From: Alan Leventhal <aleventh@muwekma.org>
Sent: Friday, June 9, 2023 11:18 AM
To: Garg, Tina
Cc: Charlene Nijmeh; Monica Arellano (via Google Sheets)
Subject: Response to the 550 PIERCY RD INDUSTRIAL PROJECT (H22-015)
Attachments: BIA Smith Letter 1998.pdf; DC District Court Muwekma.pdf; Federal Court Opinion Muwekma-1 (1).pdf; Lt. Governor Letter 2002.pdf; Miller's Restoration Bill 2000.pdf; Muwekma Elder Lucas Marine 1928 BIA.pdf; Piercy Road Project.PDF; Piercyresponse.doc.pdf; CA-SCL-732 Three Wolves Final.pdf

Thank you for the opportunity to comment on the Mitigated Negative Declaration (MND) for the proposed 550 Piercy Road Industrial Development. Please accept and consider these comments on behalf of Golden State Environmental Justice Alliance (GSEJA). Also, Golden State Environmental Justice Alliance formally requests to be added to the public interest list regarding any subsequent environmental documents, public notices, public hearings, and notices of determination for this project. Send all communications to Golden State Environmental Justice Alliance P.O. Box 79222 Corona, CA 92877.

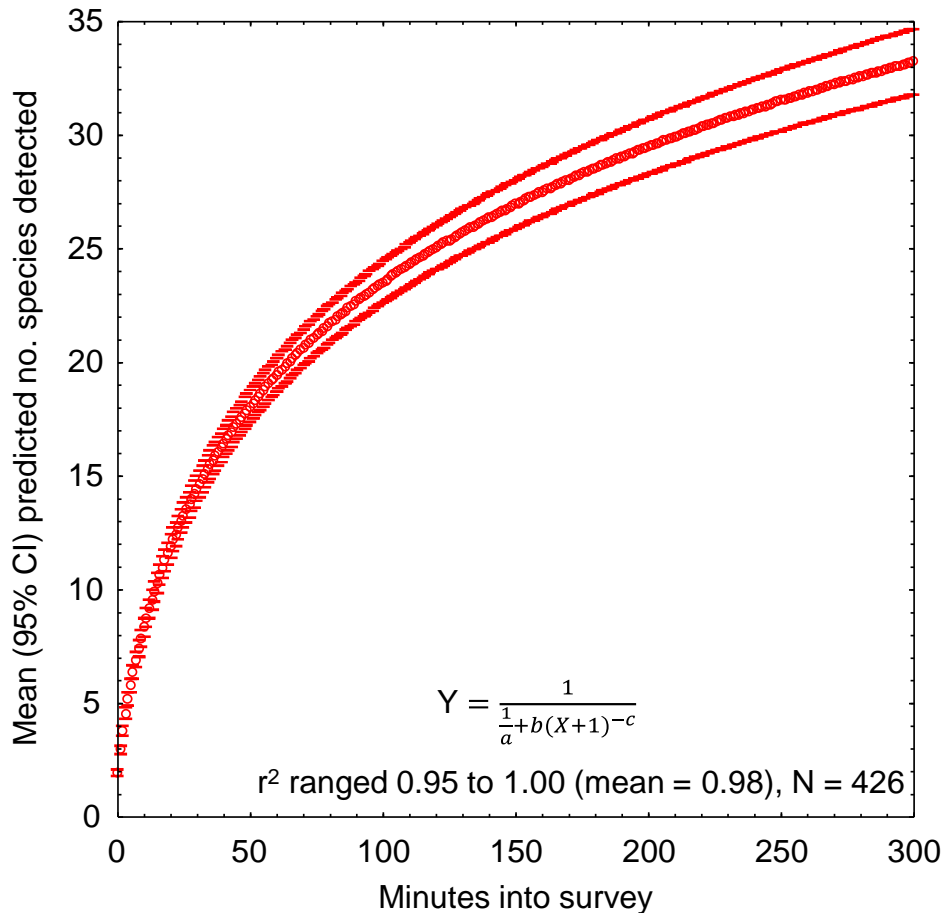
The IS/MND fails to report which species of plants and wildlife were observed by the biologist who performed the reconnaissance survey. The closest that Denise Duffy & Associates comes to reporting which species of wildlife were observed can be found in the following passage, “suitable animal burrows were observed within the project boundary” (p. 16), although the species that excavated these burrows were not identified. Nevertheless, this passage refutes the highly misleading claim made in the IS/MND (p. 65) that “The project is proposed in a semi-urbanized setting and has not been found to contain any native resident or wildlife species.” Although they do not report which species they observed, Denise Duffy & Associates (2023) does not report that their survey failed to detect any wildlife species.

I have completed hundreds of reconnaissance-level surveys throughout California. Never have I completed a survey without detecting any species of wildlife, not at annual grasslands, not at the most extreme desert environments, and not on paved parking lots. The number of wildlife species I detect is a logistic function of survey time, in which the most rapid rate of species detections occurs soonest after the survey begins, and diminishes as the survey continues (Figure 1). Even if Denise Duffy & Associates surveyed for only one minute, an explanation would be needed as to how no species were detected during a time period (1 minute) when I averaged nearly 2 species per survey (95% CI: 1.78–2.07 species). Had the biologist surveyed for only one hour, how is it that he detected no species of wildlife whereas over that time period I averaged 19.3 species (95% CI: 18.6–20.0 species)?

Figure 1: VMT per Employee as Calculated in the San Jose VMT Evaluation Tool¹

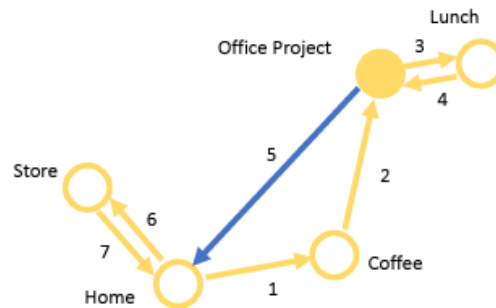
Figure 1 reproduces an illustration of how VMT per worker is calculated in the Tool. In the example, only half of the commute traffic is counted because the worker stopped for coffee on the way to work. Even if the home-to-coffee segment (#1 in the graphic) is only 100 feet and the coffee-to-work segment (#2) is 50 miles, neither segment is attributed to the project. In this example, it would be much more accurate and useful to also attribute segments 1 and 2 to the project because the coffee stop is likely just a pass-by stop, with no additional VMT, and therefore all the #1 and #2 VMT is attributable to the project as commuting travel.

Figure 2: MTC Travel Model One Commute Trip Validation⁴

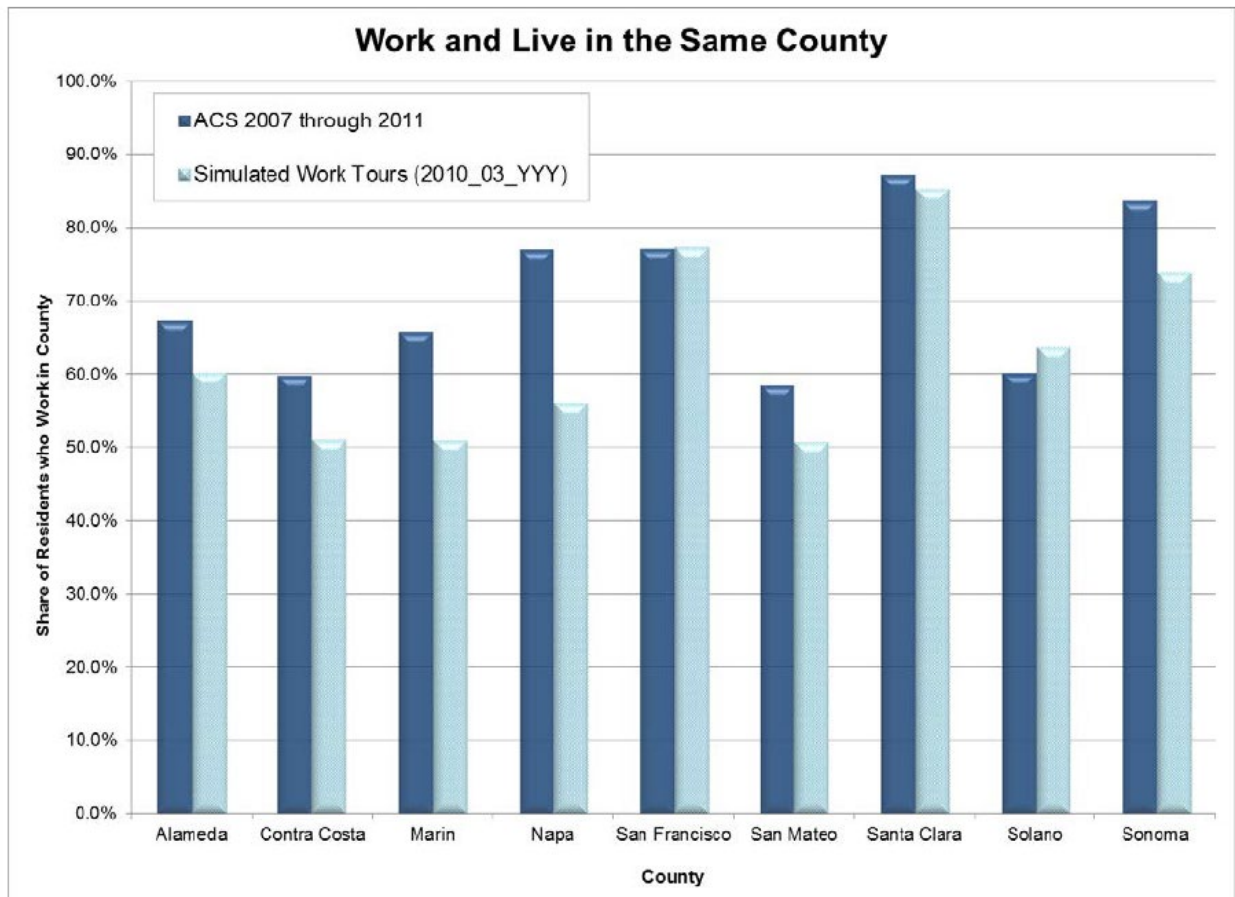
The MTC Travel Model One documentation provides no evidence that the model can accurately estimate commute patterns. Instead, it only documents that the model isn't particularly good even at estimating the proportion of a county's workers commuting to jobs in the same county (reproduced as Figure 2).

There is no discussion in the documentation concerning any Model One validation at a smaller than county geography.

Figure 3: Project Area Used in LODES Mapping

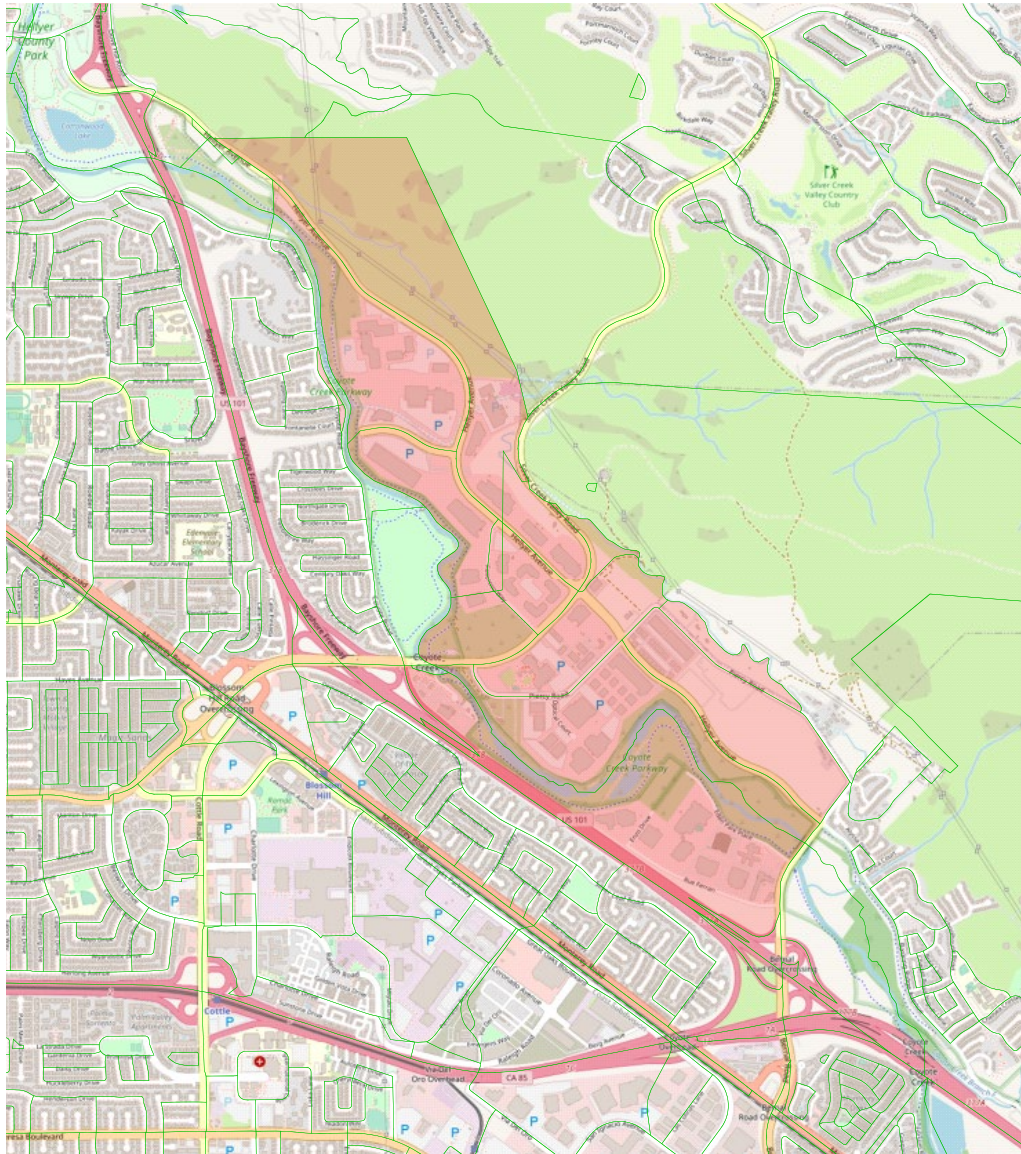
Focusing on workers commuting to the project area mapped in Figure 3, Figure 4 shows 2019 (pre-pandemic) home locations from the LODES data.

Figure 4: Project Area Workers' Home Locations⁶

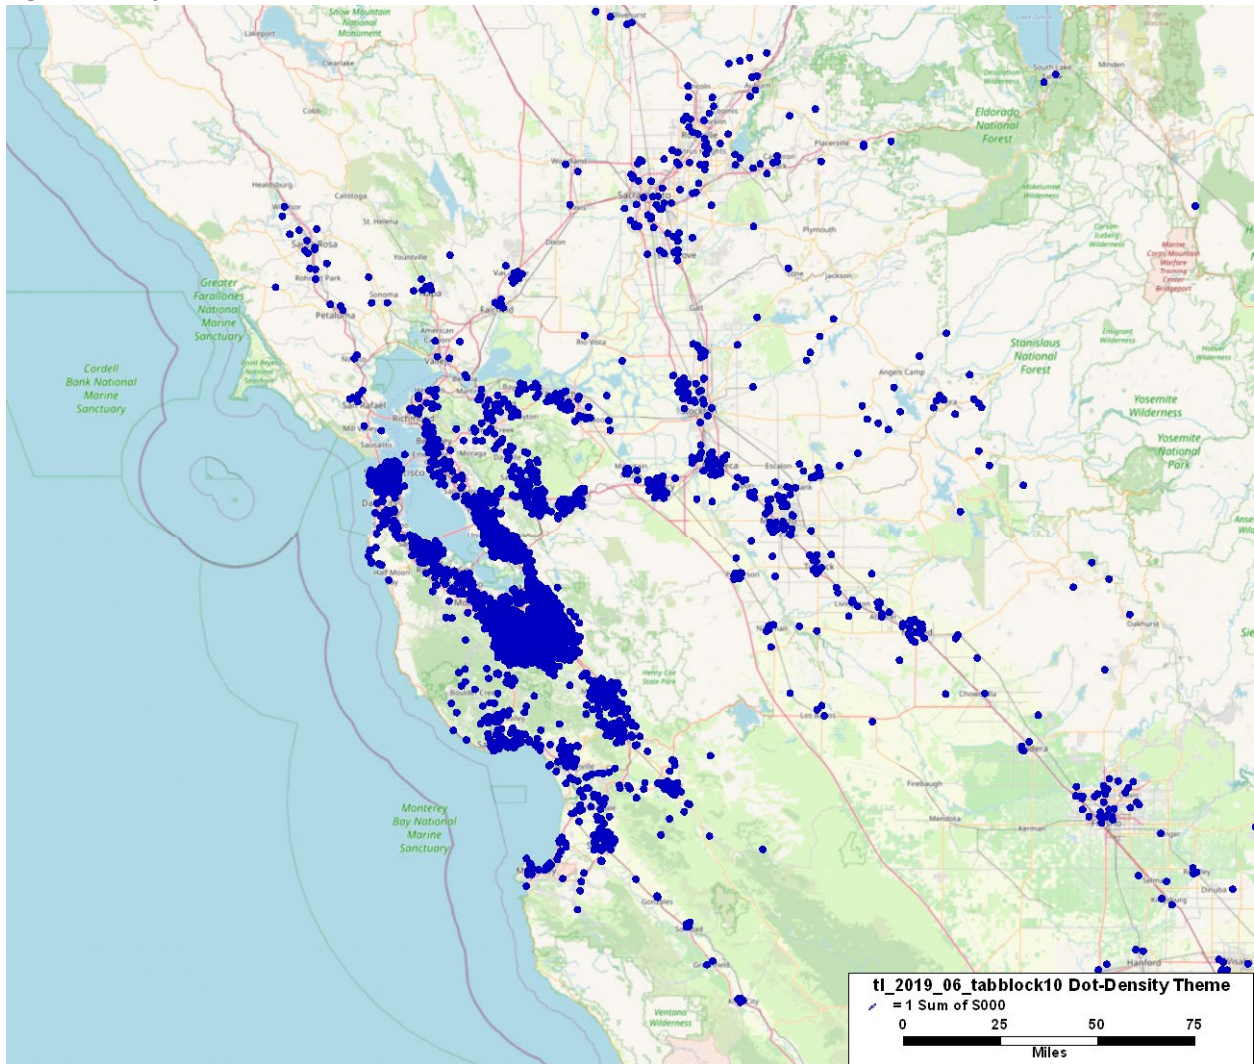
There is a cluster of workers with short commutes, but the residences of project workers are spread widely throughout the greater Bay region and beyond.

After subtracting out LODES trips that appear to be longer than 100 miles – some of which represent errors in the data – the mean distance between home and work for project area workers is 18.6 miles. Several adjustments must be made to calculate commuting VMT per worker per day. First, this is a one-way distance which needs to be doubled for round trips. Second, it is a straight-line “as crows fly” distance and the road distances are longer. On the other hand, some commuters carpool and not all commutes are by auto.

Figure 5: Project Area Census Tract for Census Transportation Planning Package Data

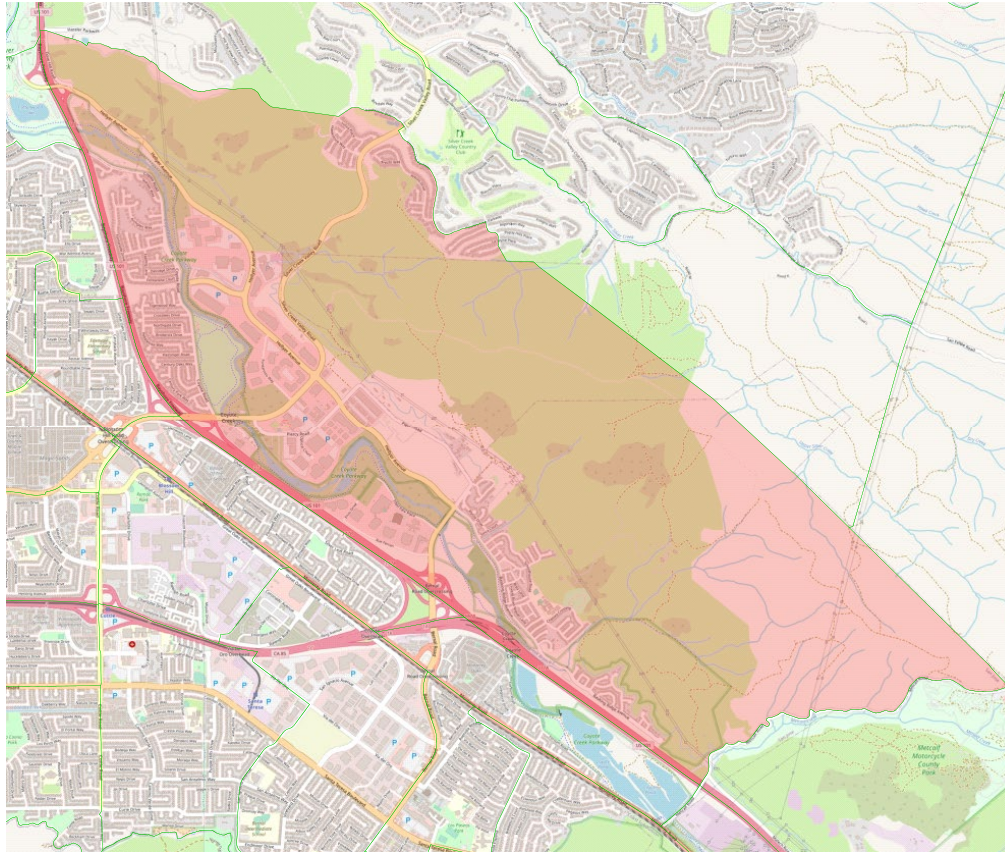
A different Census product, the Census Transportation Planning Package (“CTPP”) reports commute mode to Census Tracts. Figure 5 shows the three Tracts selected to represent the project area.

In the project Census Tract, 98.8 percent of commutes to jobs in the project area are made by auto, with an average occupancy of 1.058. 0.7 percent of the commutes are completed by walking, 0.2 percent by bike, and 0.3 percent by transit.⁷
